STATE OF WASHINGTON
DEPARTMENT OF ECOLOGY

June 18, 2018

Re: Opinion pursuant to WAC 173-340-515(5) on Proposed Interim Action for the following Hazardous Waste Site:

- **Name:** Northwest Plating
- **Address:** 825 South Dakota Street, WA 98108
- **Facility/Site No.:** 2231
- **VCP No.:** NW2769
- **Cleanup Site ID No.:** 1361

FIGURE 23
SHALLOW GROUNDWATER TCE ISOCONTOURS FOR
DECEMBER 2015 (IN µg/L)

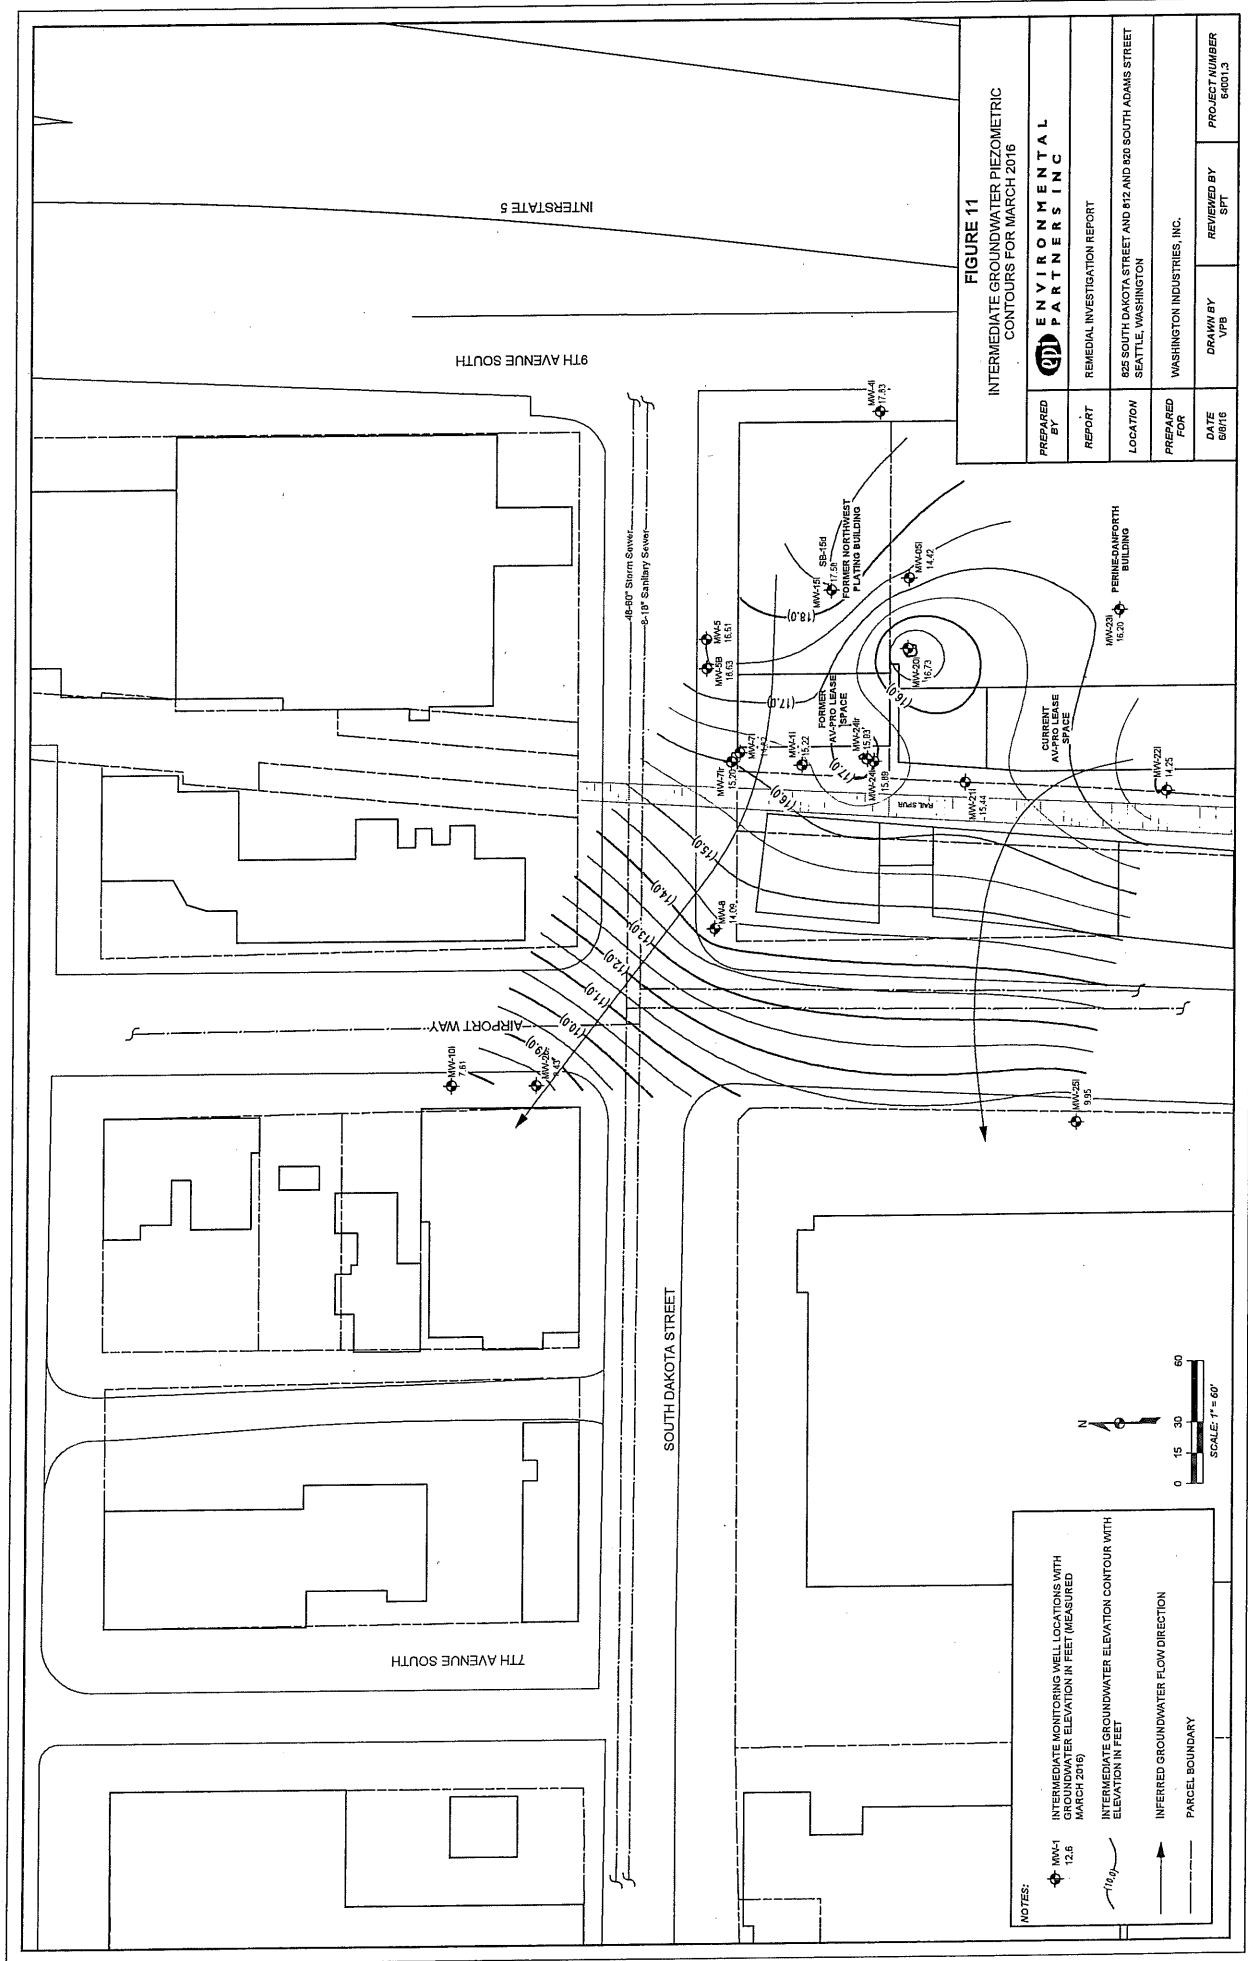
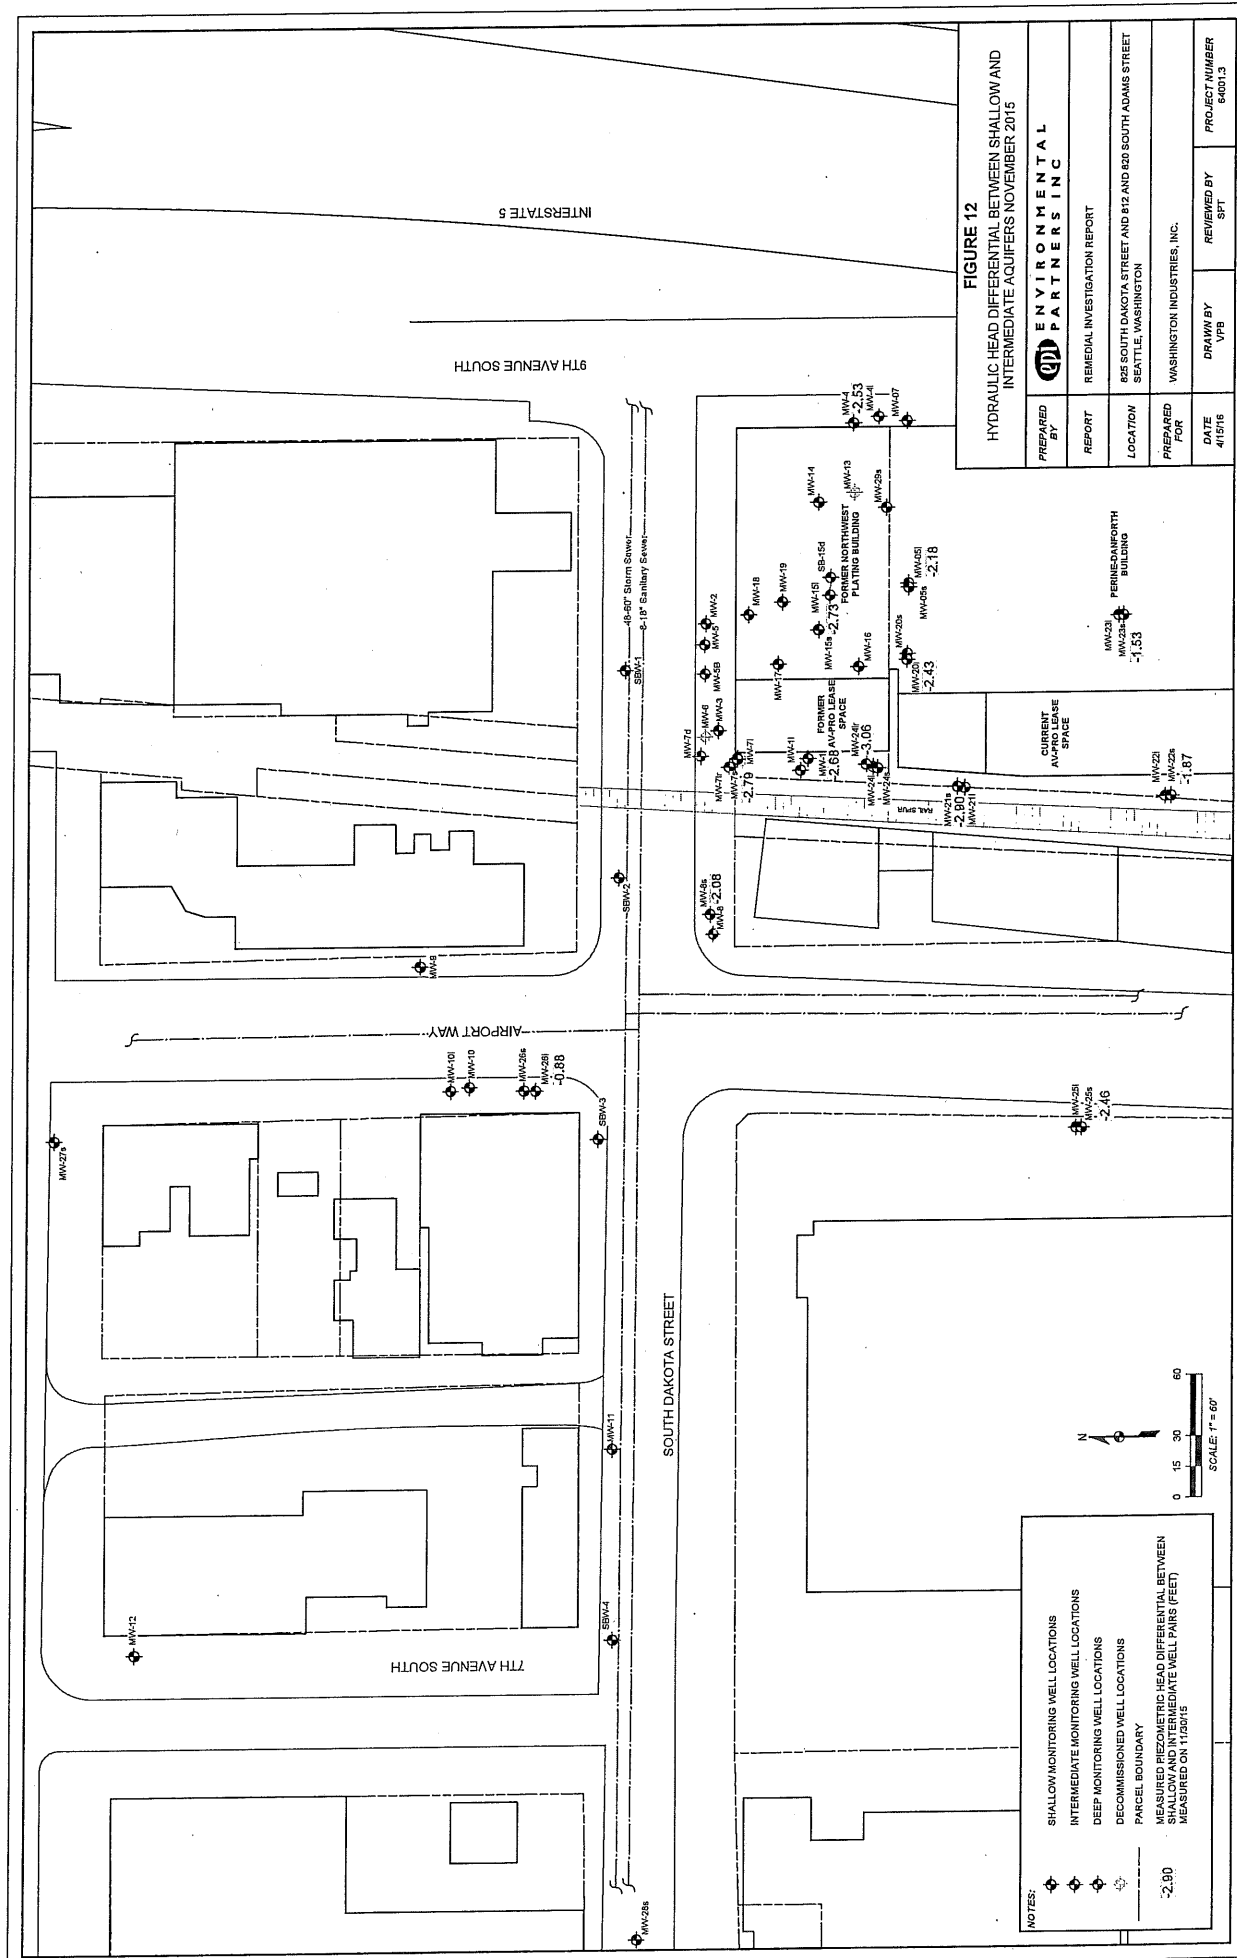
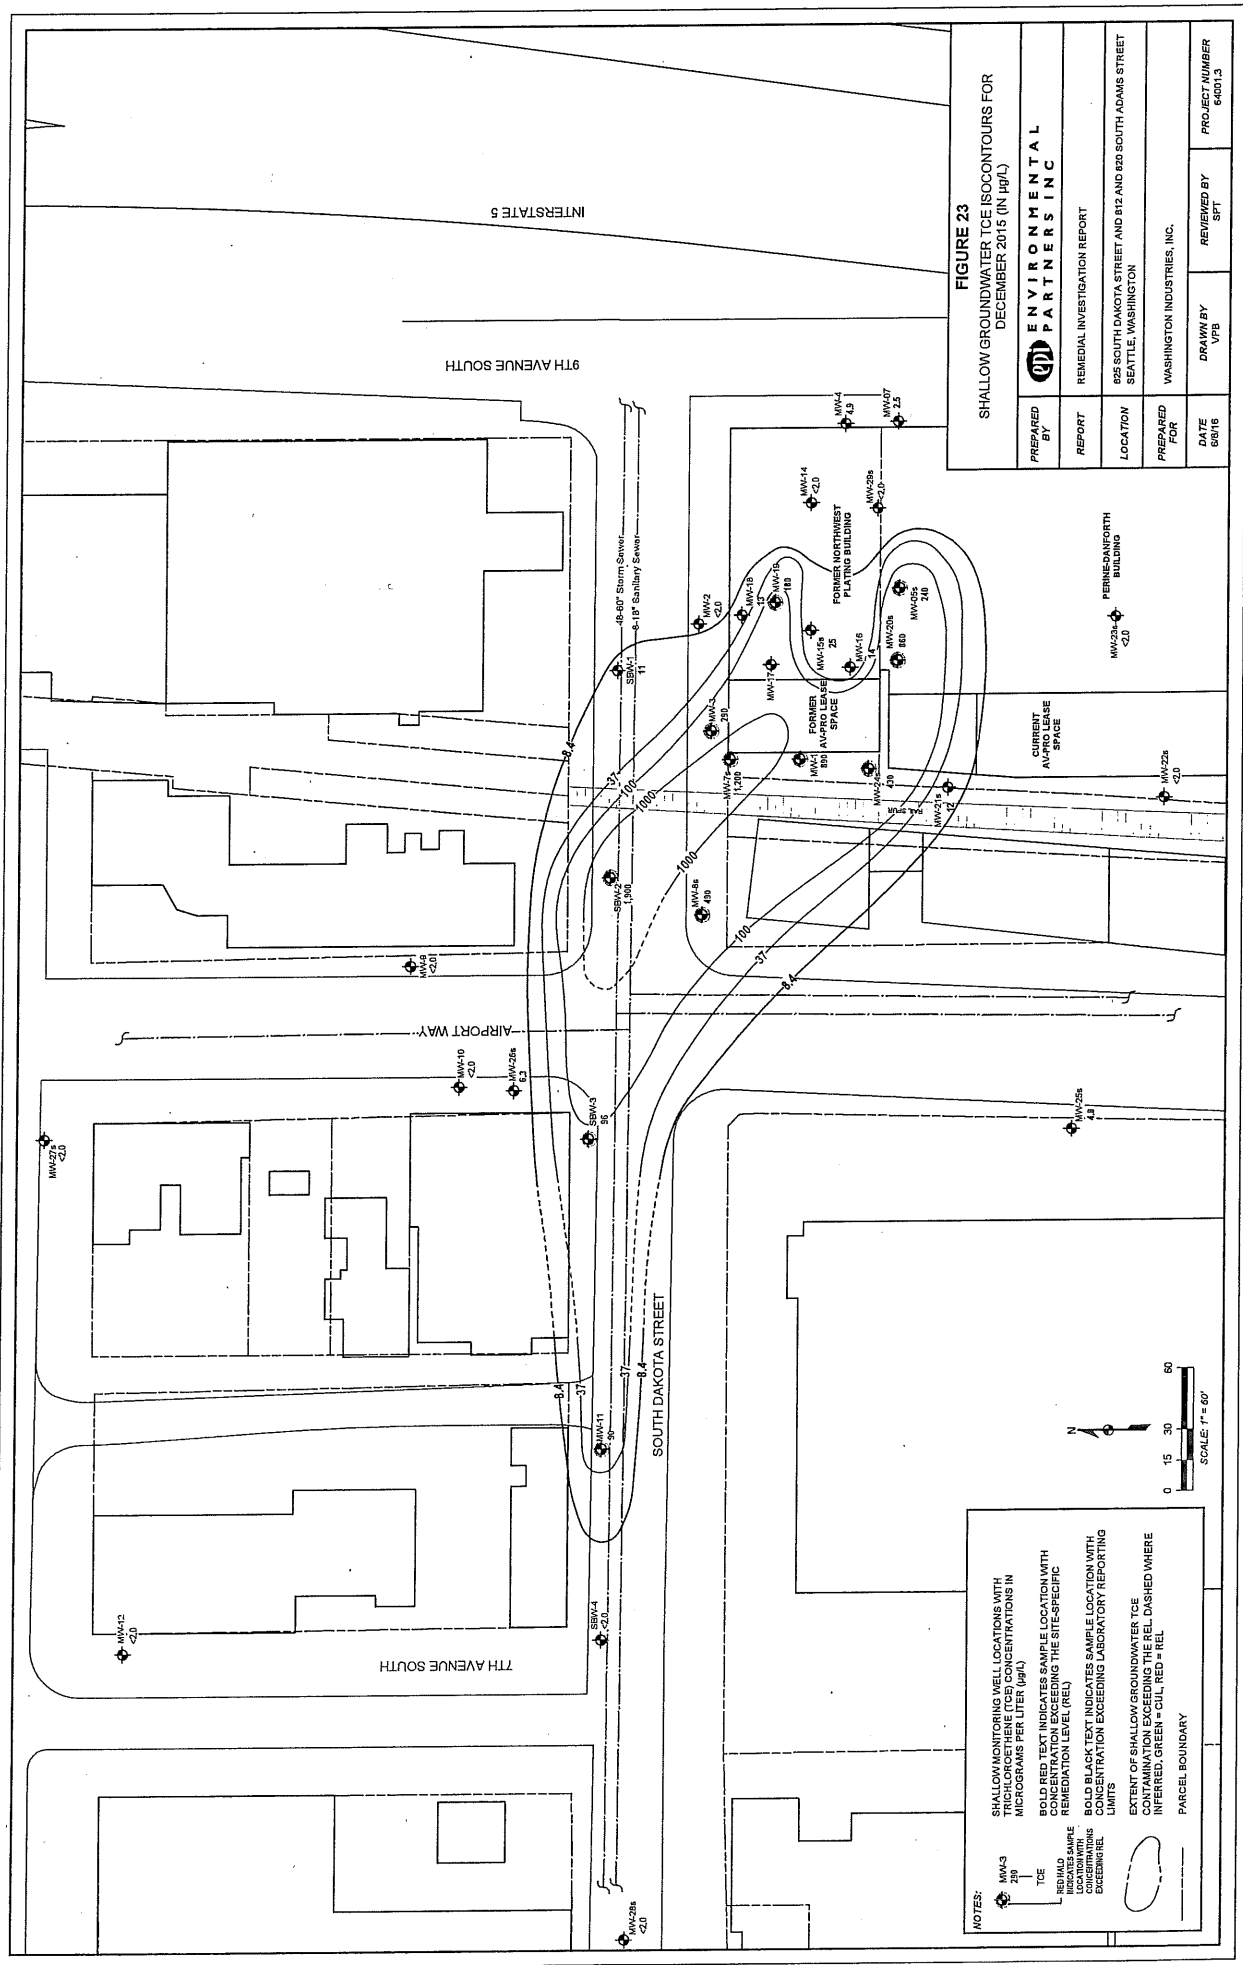
- Figures 18 through 22: Please include TCE data collected on the Perine parcel in the iso-concentration contouring.
- Figures 23 through 25: Please use the Method A cleanup level for TCE in ground

water to draw the TCE plume. Please also add figures showing impacts to the intermediate aquifer on different dates, including current data.
